Mandatory Product Update/Safety Bulletin

PCWU 15-012
 PC3/Titan Overspeed Safety Device - Safety Bulletin
 October 12, 2015

SUB COMPONENT
Overspeed Safety Device - Flywheel Assembly

FIG D1 - Pass

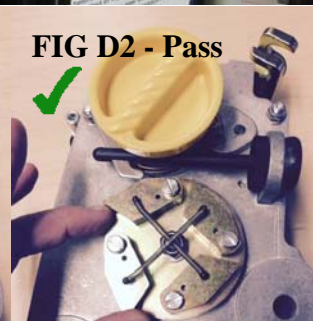
1. Prior to performing Daily Inspection Procedure checks, with Service Lift power off, remove Hoist Mainframe Cover (Fig C1) using a 4mm T-Handle. Locate the Flywheel Assembly (See Fig C2). **Manually rotate each flywheel counterweight (4 Total) on Flywheel Assembly** of the Overspeed Safety Device to ensure that their rotation past the outer diameter of the flywheel is limited as shown in Fig D1 & D2 below. If it can move too far and get caught on obstacles other than the trigger for the stop as shown in Fig E, the Flywheel does not pass inspection.

2. If Flywheel Assembly passes inspection, the Service Lift may be used as long as all other functions of the Daily Inspection Procedure have been completed. If Flywheel Assembly does not pass inspection, Service Lift must be removed from service until update has been applied.
3. Until update below has been installed, repeat steps 1-2 above prior to each daily use.
